HISTORIC AND DESIGN REVIEW COMMISSION

HDRC CASE NO: 2020-195
ADDRESS: ROW near 1430 E HOUSTON ST
LEGAL DESCRIPTION: NCB 575 BLK 14 LOT 19
ZONING: I-1, H
CITY COUNCIL DIST.: 2
DISTRICT: Dignowity Hill Historic District
APPLICANT: Steve Salinas/Modus LLC
OWNER: City of San Antonio
TYPE OF WORK: Installation of a new network wood pole
APPLICATION RECEIVED: December 3, 2020
60-DAY REVIEW: Not applicable due to City Council Emergency Orders
CASE MANAGER: Huy Pham

REQUEST:

The applicant is requesting a Certificate of Appropriateness for approval to install a new wood pole featuring network node equipment on the right-of-way on the north side of the 800 block of E Crockett, between cross streets N Mesquite to the East and N Cherry to the West, closest to the property at 1430 E Houston, at the approximate coordinates (29.423831, -98.475992).

Photo Simulation

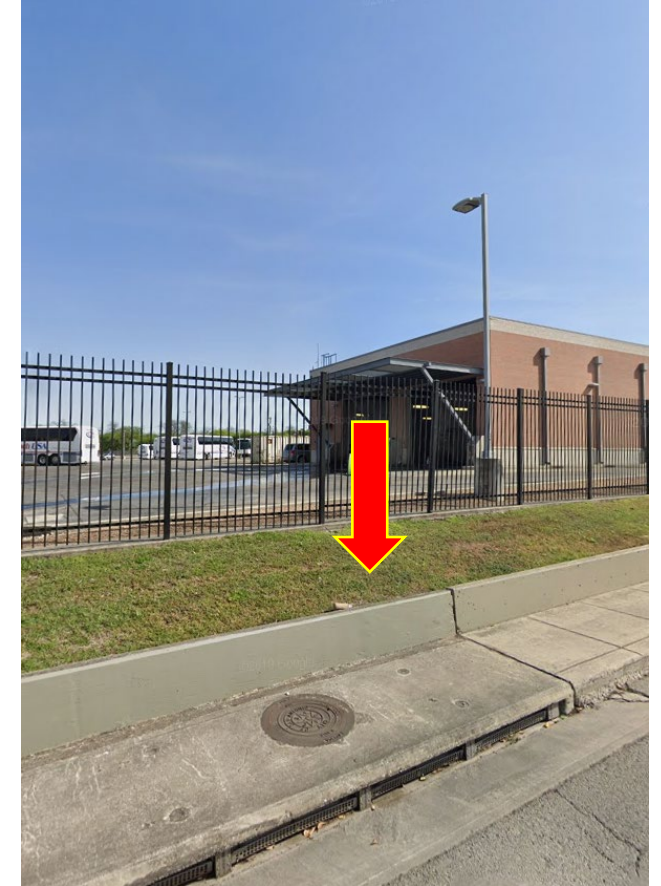
- h. DESIGN – The applicant has proposed to install a wood pole that features three (3) service cabinets at pedestrian height (fiber demarcation point (NDP), service disconnect, and meter) and three (3) access units (radio/antenna cabinets) mounted radially at the top of the pole. The applicant referenced existing wood utility poles in selecting the pole type in this location. Per the Design Manual 3.B.: *The Historic Preservation Officer may require concealment of the support pole in the form of aesthetically appropriate street lamps, site elements, district signage, or other stealth methods. The color of any new support pole or concealment solution shall be determined by the Historic Preservation Officer based on site specific conditions.* Staff finds that no effort has been made to conceal or relate the proposed new pole to the existing context – except the use of a wood pole and matching equipment color.

- i. COLLOCATION - Documented efforts to explore a nearby collocation have not been submitted.
- ii. LOCATION – The proposed pole is not located at a commercial intersection and/or in-between buildings facades.
- iii. SEPARATION – The proposed pole is not separated from existing poles by more than 250 feet.
- iv. DIAMETER – The proposed pole is not less than 8 inches at its widest portion.
- v. DESIGN – Matching wood material to existing poles does not constitute a stealth aesthetic.

- DESIGN – Matching wood material to existing poles does not constitute a stealth aesthetic.
 - RESPONSE: Verizon is proposing to have all the proposed equipment on the pole to match the color of the wood pole. There are no other current ways to stealth the proposed equipment without adding a large amount of bulk/dimension to the design. The proposed design has been approved in other historic districts locations on past HDRC agendas.

Pole on property pole

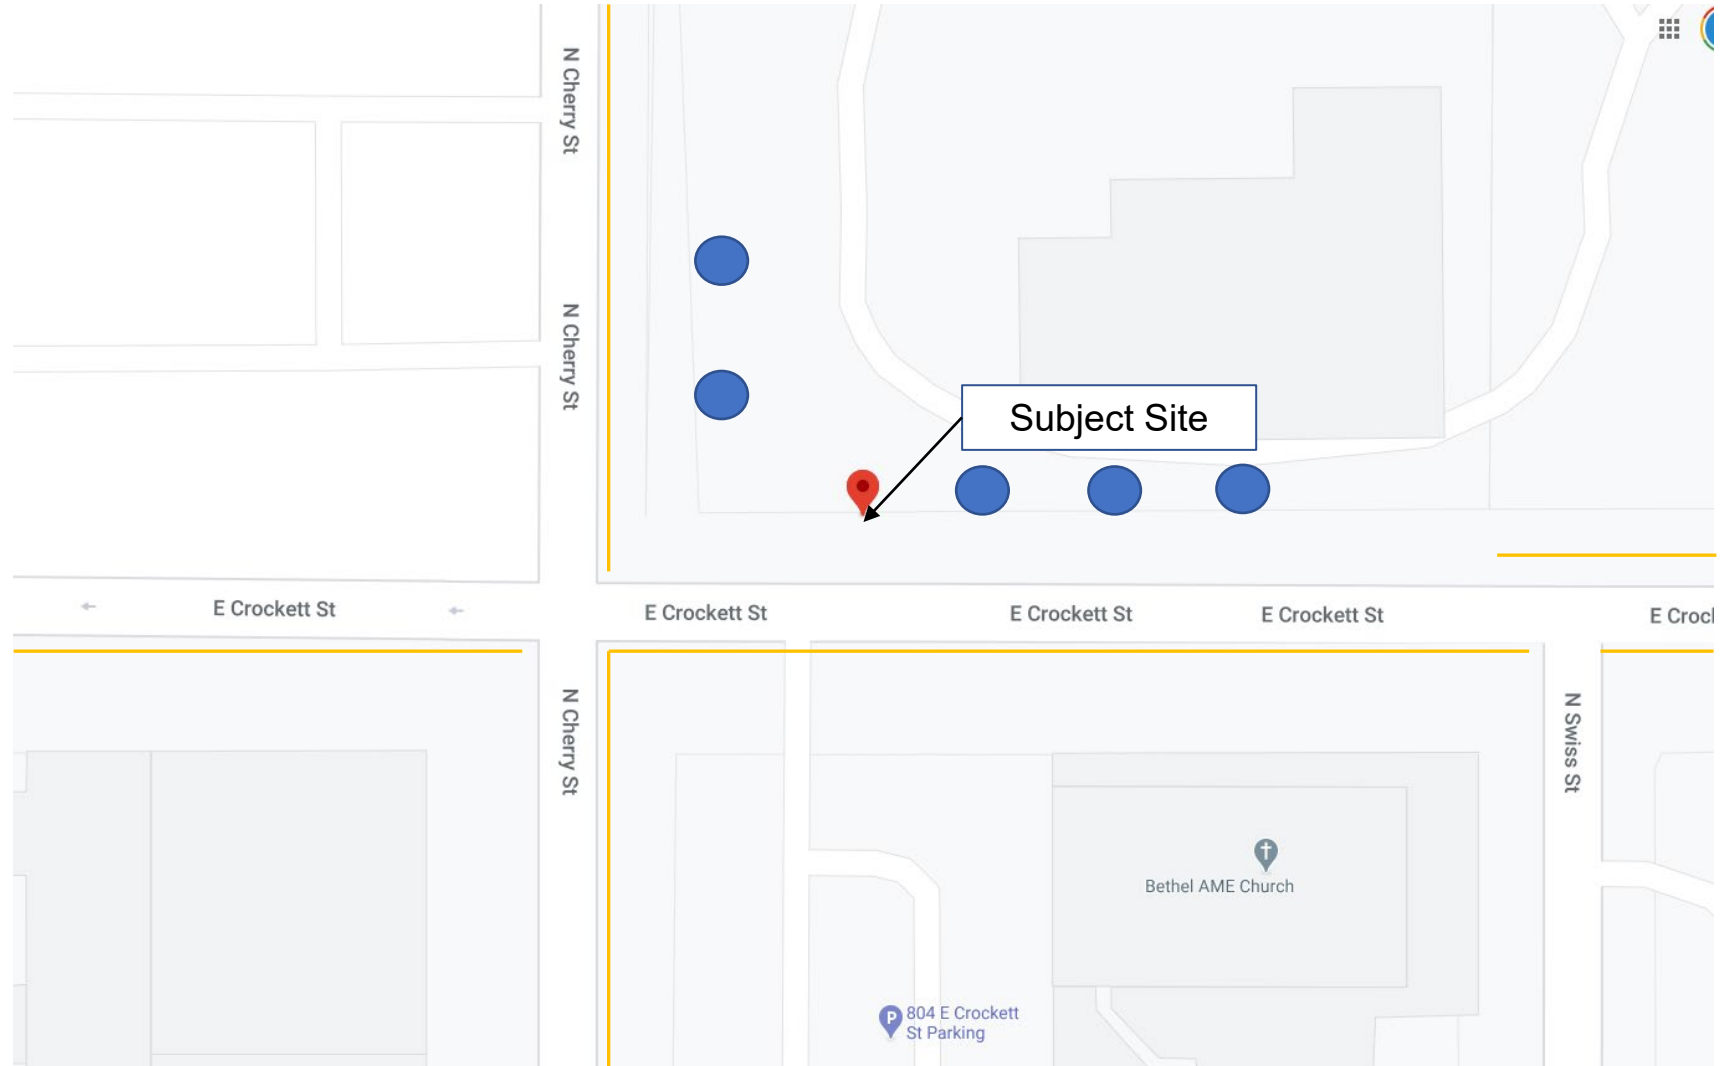
- e. COLLOCATION – Per the Design Manual 3.B.iii, where a separation requirement cannot be met, new nodes are preferred to be mounted to existing poles or installed with a stealth method. Staff finds that a collocation on existing poles should be explored prior to consideration of a new stealth pole. A letter from the owner-operator of the existing nearby poles and/or an engineer’s letter noting the feasibility of collocation will suffice as a supporting document for this finding.

No existing viable vertical assets. All nearby CPS poles are not viable colocation candidates since they are either transformer poles or have risers on them which CPS doesn't allow

- COLLOCATION - Documented efforts to explore a nearby collocation have not been submitted.
 - RESPONSE: See previous two slides. There are no viable existing collocatable poles in the immediate area where Verizon's radio frequency engineer has noted a need for coverage/data capacity improvements
